**Addendum No. 1 December 13, 2024**

**Craft Center Upgrades**

**Tennessee Technological University**

**Revisions and Clarifications to the Drawings or to the Project Manual:**

ROOF DETAIL

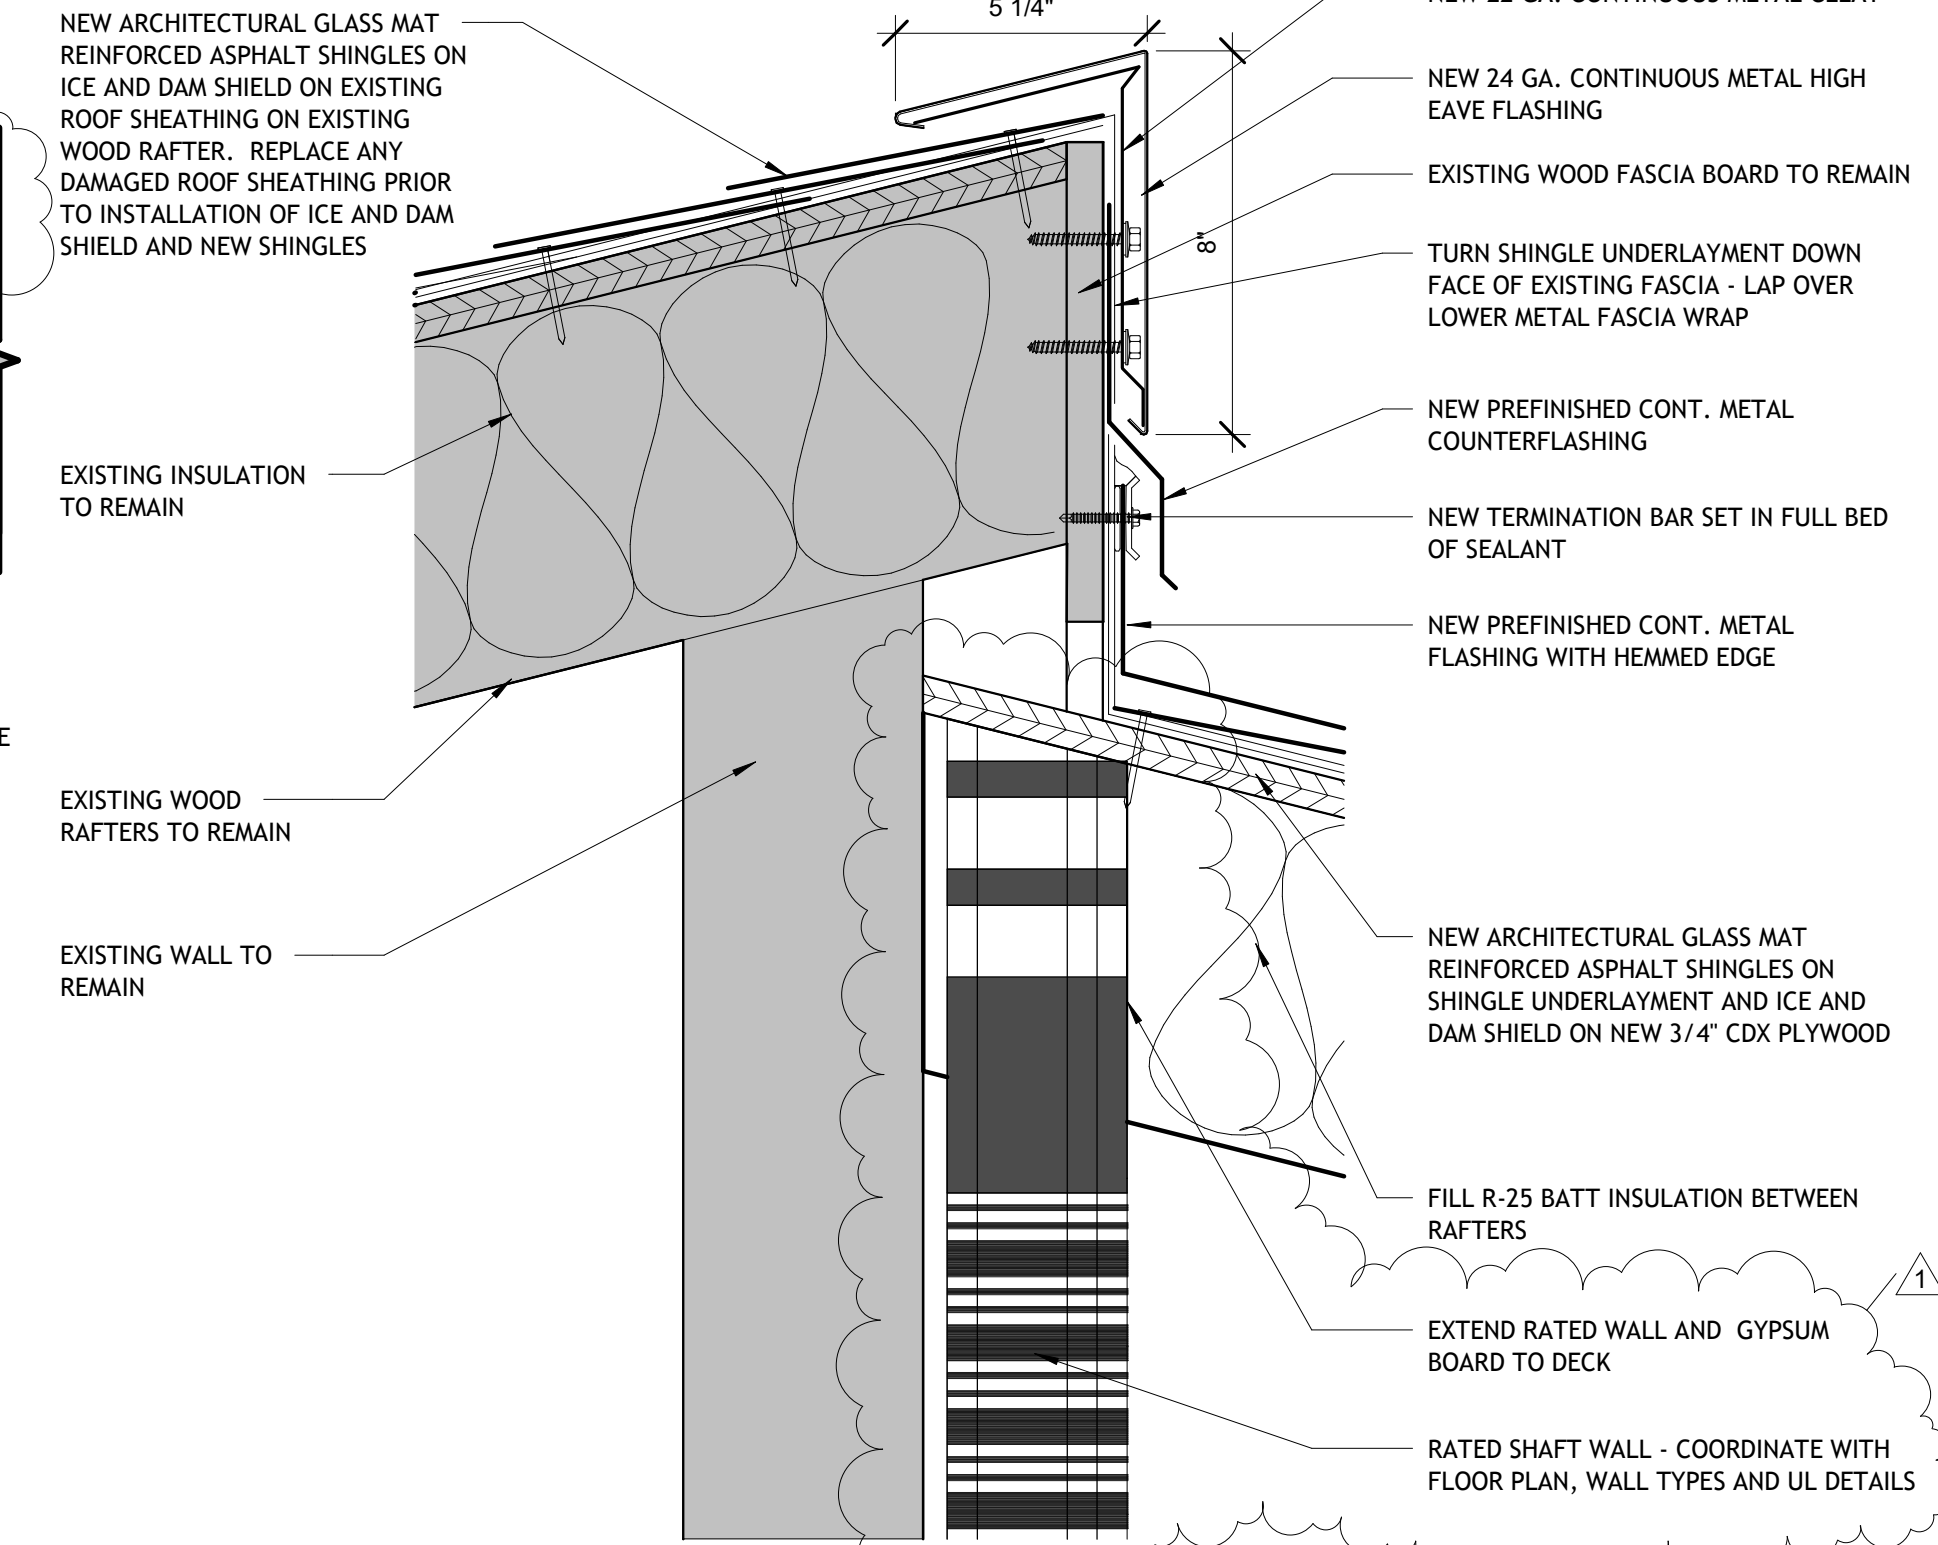
6. Refer to sheet A1.4 Admin Building Roof Details – Detail 4. Remove detail as it is not used.
7. Refer to sheet A1.5 Roof Details, details 1, 2, and 3. Remove references to built-up roof to remain. Change note to read "Remove existing EPDM roofing prior to placement of the hailguard board."

8. Refer to sheet A1.5 Roof Details, details 2 and 6. The downspout and gutters are existing to remain. Change references of new gutters and downspouts to read per attached revised. Remove references to repainting existing fascia to remain.

ROOF DETAIL

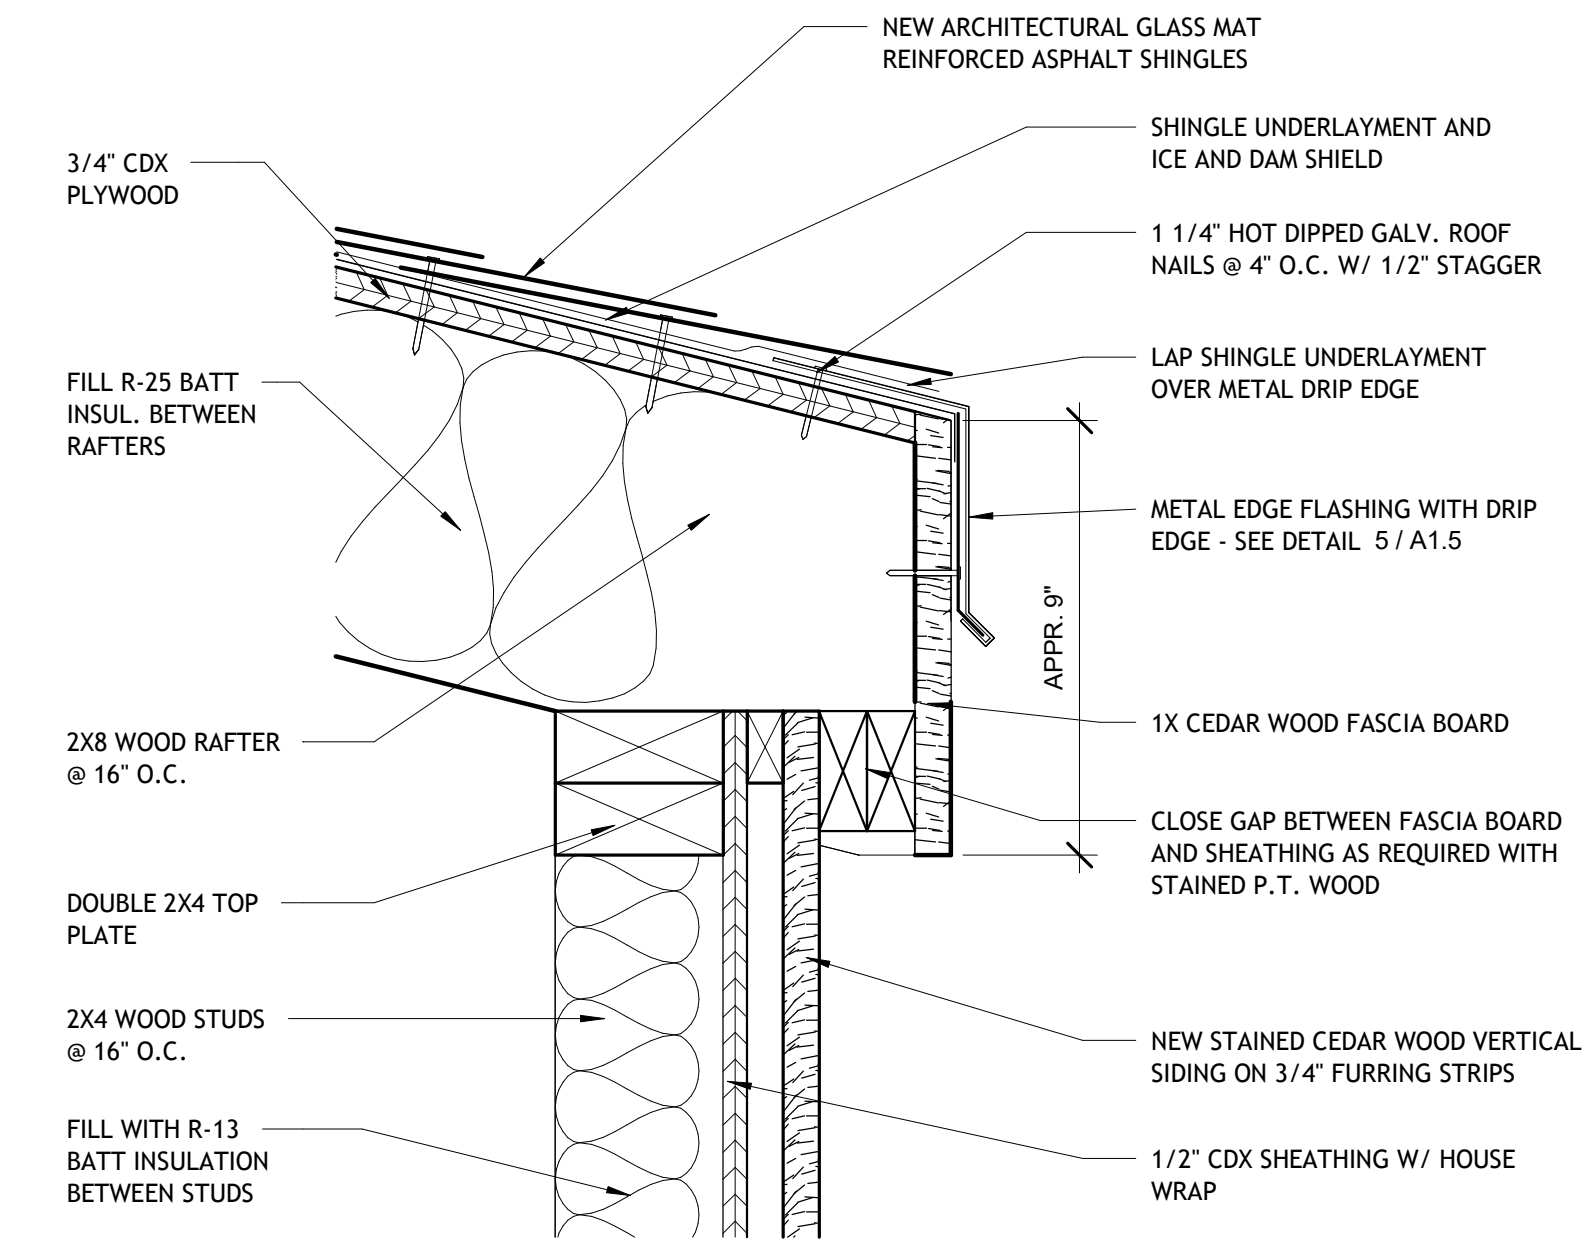
9. Refer to sheet A1.5 Roof Details, details 3, 4, 6 and 7. Remove reference to  $\frac{3}{4}$ " CDX plywood on 1  $\frac{1}{2}$ " P.T. wood sleepers at 24" clear and 1.3 rigid insulation board between wood sleepers. Remove references to repainting existing fascia to remain.
